03E-010

Safety Defect and Noncompliance Report Guide for Equipment

PART 573 Defect and Noncompliance Report¹

Generic name of the item: Crankshaft Vibration Damper

Crankshaft vibration damper with cracked center hub

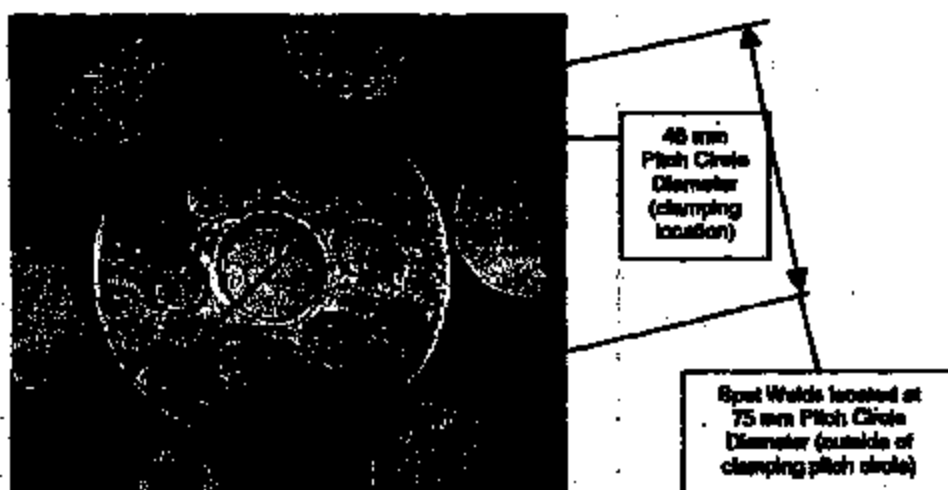
Vibration dampers fitted to the engines listed above were manufactured with a spacer plate that is attached to the vibration damper center hub by 6 spot welds located at a pitch circle diameter of 75 mm. This location is outside of the vibration damper mounting capscREW clamping area (which is 48 mm pitch circle diameter). This area naturally flexes with the torsional movement of the vibration damper. The welded area of the hub is more rigid, and the torsional flexing causes some of the vibration damper hubs to crack.

The first 75 vibration dampers were correctly manufactured to the Cummins print specification. A change to this print was made by Cummins Inc. prior to 1/1/2001 that specified 3 spacer plate spot welds located at a pitch circle diameter of 48 mm. The supplier failed to implement this specified change, and the remaining 1,211 dampers were manufactured with 6 spot welds located at a pitch circle diameter of 75 mm. This spot weld location is outside of the vibration damper mounting capscREW clamping area. This area naturally flexes with the torsional movement of the vibration damper. The material hardness of the spacer plates welded to these vibration dampers is at the upper limit of the Cummins' specification. This material characteristic combined with the rigid

characteristics of the spot welds and the natural torsional movement of the hub has caused some of the vibration damper hubs to crack.

Describe the consequence(s) of the defect or noncompliance condition.
Damper spacer plate spot welds located outside of a 48 mm pitch circle diameter can cause the center hub of the vibration damper assembly to fracture due to material fatigue (as shown below).

The remedy for current and future engine production is the utilization of a vibration damper that is manufactured with 3 spacer plate spot welds located at a pitch circle diameter of 48 mm. Further, the 1287 recall engines are to be fitted with a vibration damper that is manufactured with 3 spacer plate spot welds located at a pitch circle diameter of 48 mm.

The vibration damper spacer plate is to be attached to the damper assembly with 3 spot welds located at a pitch circle diameter of 48 mm versus the recall vibration dampers that were manufactured with 6 spacer plate spot welds located at a pitch circle diameter of 75 mm.
